CONSTRUCTION MANAGEMENT CHANGE PROPOSAL

Re: Our Change Proposal 25069-04 for **Revised Architectural Drawings - Roof Plans and Specifications**

Project: Delray Beach CRA Exterior and Interior Art Warehouse Repairs | 313 N.E. 3rd Street, Delray Beach
Arts Warehouse
Arts Warehouse, 313 N.E. 3rd Street, Delray Beach, FL 33444

PROJECT TITLE
**ROOF REPAIRS AT
THE ARTS
WAREHOUSE
FOR DELRAY CRA**

A0.0

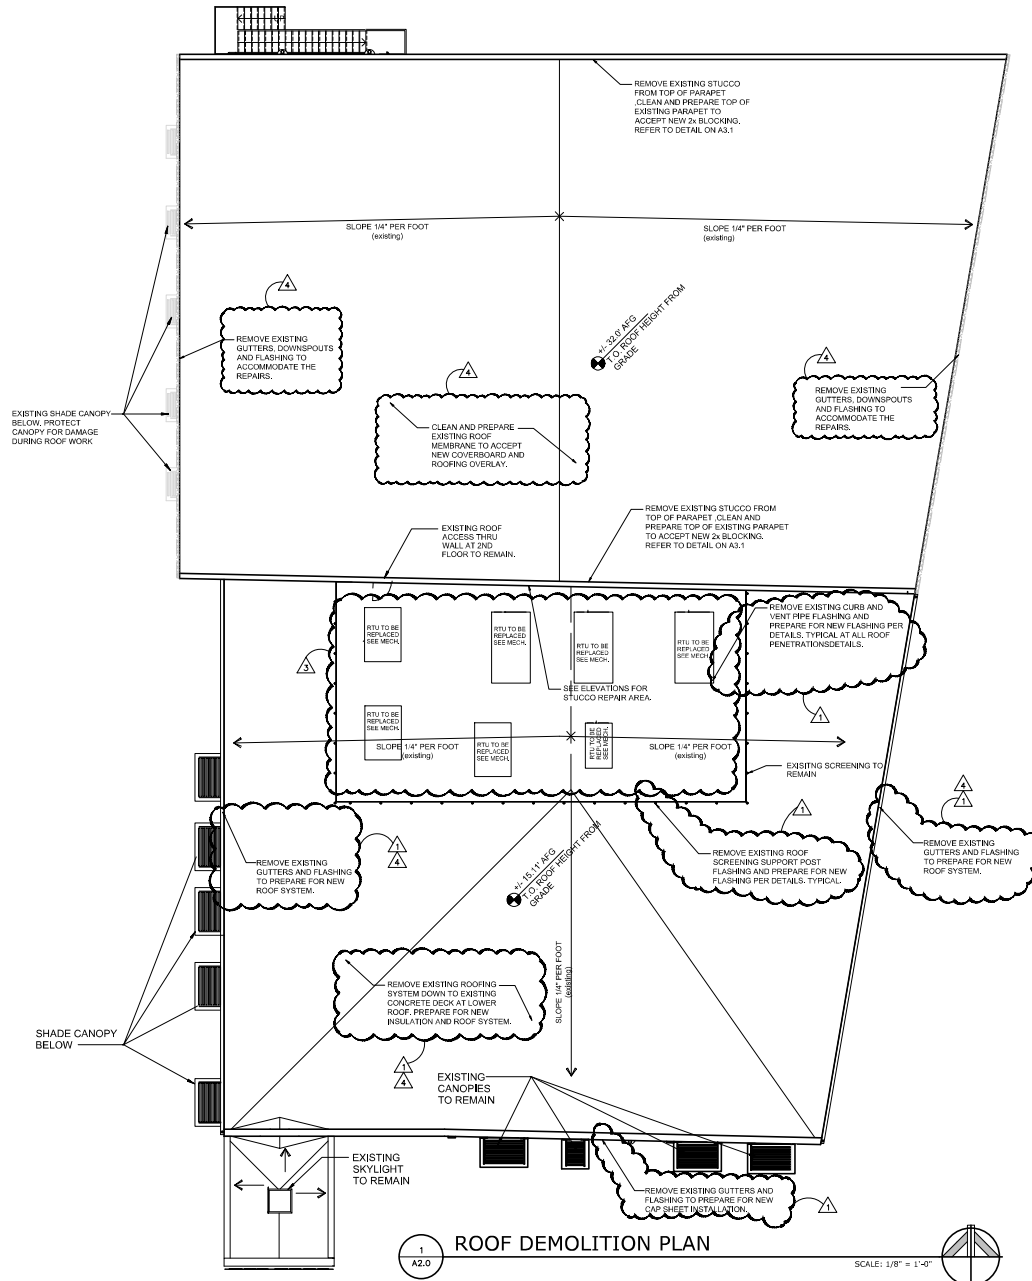
** AMENDED SCOPE OF ROOFING WORK, POST PULL TEST RESULTS. THE UPPER ROOF REPAIRS/OVERLAY HAD TO BE REVISED TO INCLUDE A MIN. 1/8" ASPHALTIC COVERBOARD OVER THE EXISTING MEMBRANE AND THEN THE OVERLAY AS DETAILED ON A1.1.	
THE LOWER ROOF IS NO LONGER AN OVERLAY. DUE TO TEST RESULTS, THE EXISTING ROOF SYSTEM AND INSULATION MUST BE REMOVED AND REPLACED AS DETAILED ON A1.3.	
CODE COMPLIANCE SUMMARY	
FLORIDA BUILDING CODE - 2023 8th EDITION WITH APPLICABLE AMENDMENTS FLORIDA EXISTING BUILDING CODE - 2023 8th EDITION WITH APPLICABLE AMENDMENTS FLORIDA PLUMBING CODE - 2023 8th EDITION WITH APPLICABLE AMENDMENTS FLORIDA FUEL GAS CODE - 2023 8th EDITION WITH APPLICABLE AMENDMENTS FLORIDA MECHANICAL CODE - 2023 8th EDITION WITH APPLICABLE AMENDMENTS FLORIDA ACCESSIBILITY CODE - 2023 8th EDITION WITH APPLICABLE AMENDMENTS FLORIDA ENERGY CONSERVATION CODE - 2023 8th EDITION WITH APPLICABLE AMENDMENTS FLORIDA FIRE PREVENTION CODE - 2023 8th EDITION WITH APPLICABLE AMENDMENTS NATIONAL ELECTRIC CODE - 2020

DRAWING NUMBER
A3.1

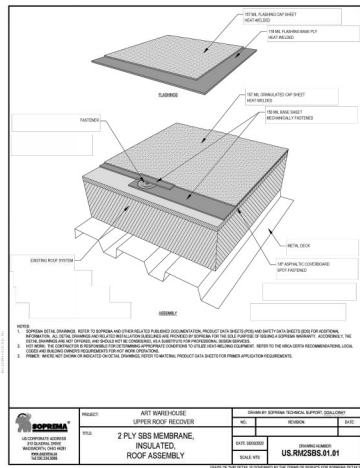
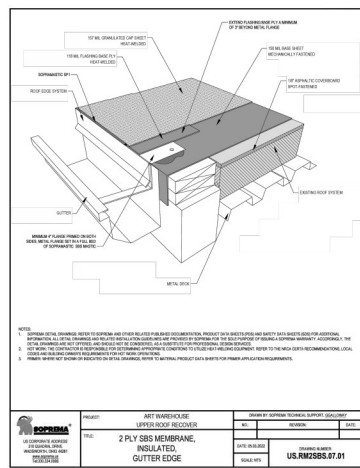
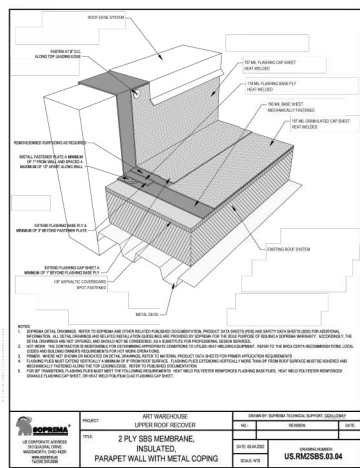
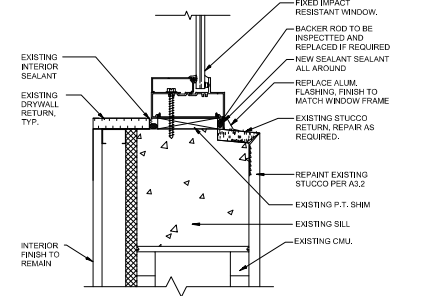
This Change Order reflects revisions to the roofing scope based on updated design requirements following pull test results, differing from the original drawings. The revised plans require the upper roof to include an asphaltic coverboard and new multi-layer overlay system per Sheet A-3.1, and the lower roof to be converted from an overlay to a full reroof per Sheet A-3.3, including removal of the existing system and installation of a new roofing assembly per specifications and manufacturer requirements.
